# CITY OF ALBUQUERQUE

Planning Department

February 21, 2018

RE: **Lot 1 Block 2 Unit 18, S.A.D. 228**  
**Volcano Cliffs Subdivision**  
**6616 Petirrojo Rd. NW**  
**Grading and Drainage Plan**  
**Engineers Stamp Date 2/19/18 (D10D003G1)**

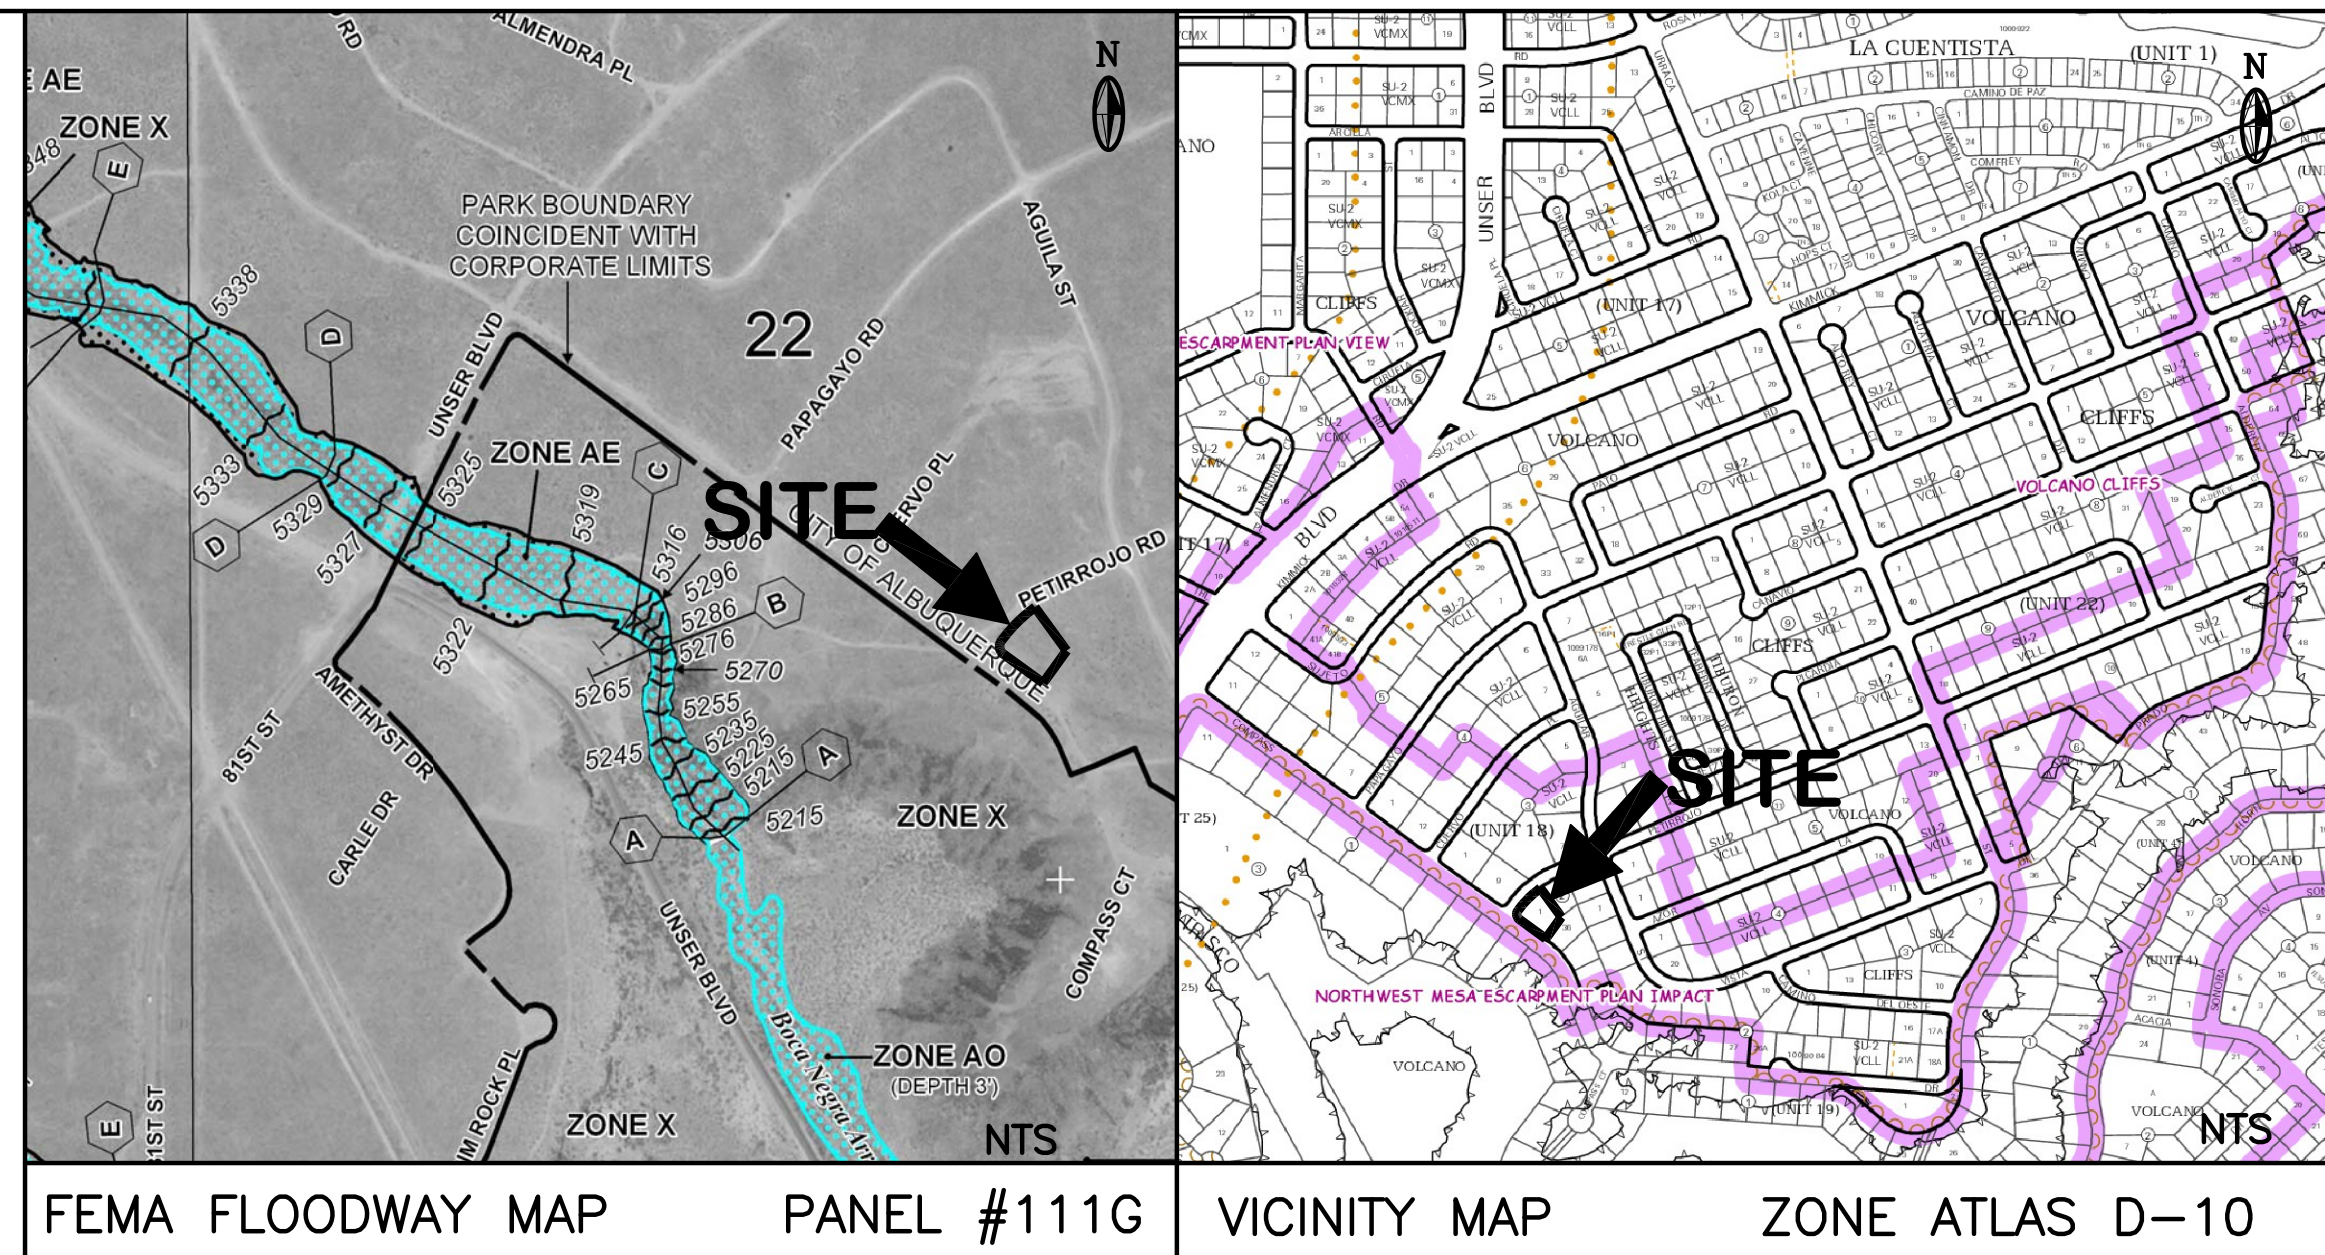
Based upon the information provided in your submittal received 2/20/18, this plan is approved for Grading Permit.

**Prior to Building permit approval a Pad Certification will be required, provided by the Engineer or a registered Land Surveyor.**

Reiterate to the Owner/Contractor that a separate permit for a garden/retaining wall must be obtained, with the approved G&D plan dated 2/19/18.

Prior to Certificate of Occupancy release, Engineer Certification per the DPM checklist of this plan will be required.
